Annual Monitoring Report

Mill Dam Creek Restoration Site
Yadkin River Basin - 03040101
Monitoring Year 04
DEQ Contract 6898
DMS Project Number 97136
RFP#16-006706 (Date of Issue: October 21, 2015)

MEMORANDUM

Date: February 21, 2024
To: Matthew Reid, DMS Project Manager
From: Adam Spiller, Project Manager
KCI Associates of North Carolina, PA
Subject: Mill Dam Creek Stream Restoration Site
MY-03 Monitoring Report Comments
Yadkin River Basin CU 03040101
NCDMS Project # 97136
Contract # 6898

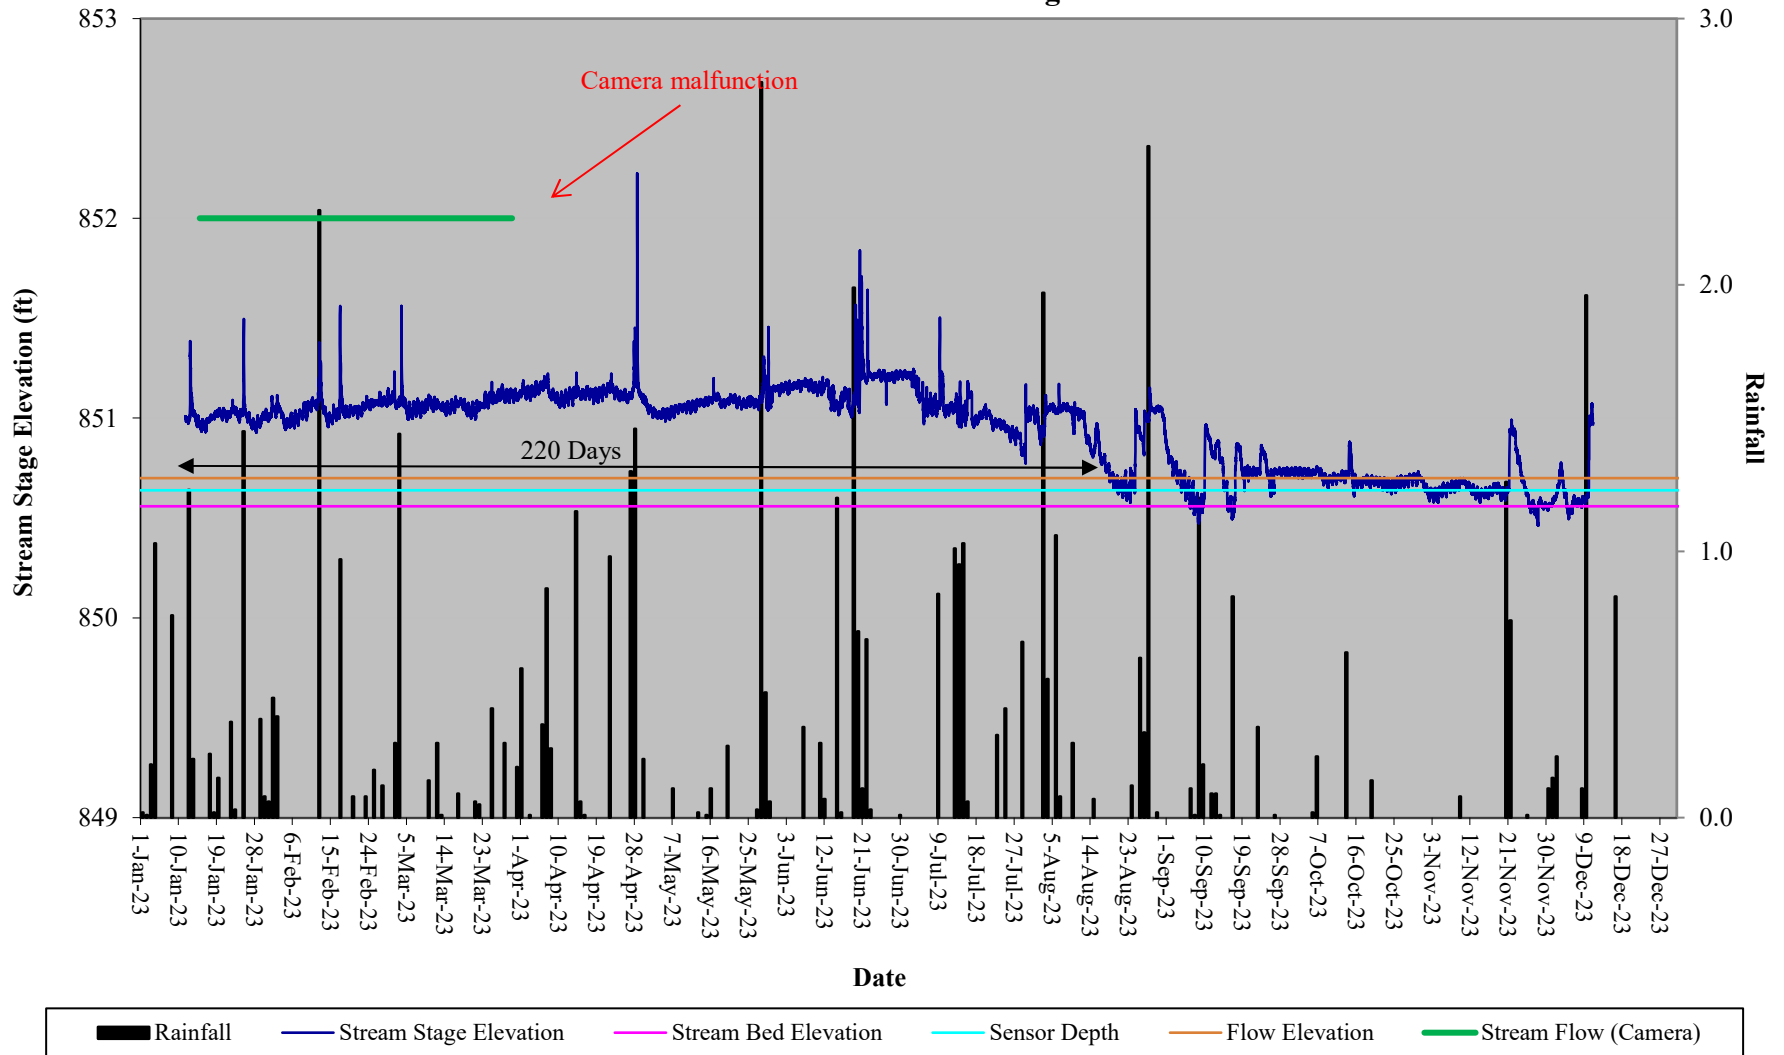
- Table 2: Please include the live stake supplemental planting and invasive species treatment that occurred in MY4.
KCI Response: This change has been made.
- T8A stream flow gauge graph indicates that there was a camera malfunction. Has this camera been repaired or replaced?
KCI Response: This camera has been replaced with a functioning one.
- Please continue to include Appendix F from previous year report in all monitoring reports. The IRT communications are helpful for reviewing the site history.
KCI Response: Appendix F has been included in the report.
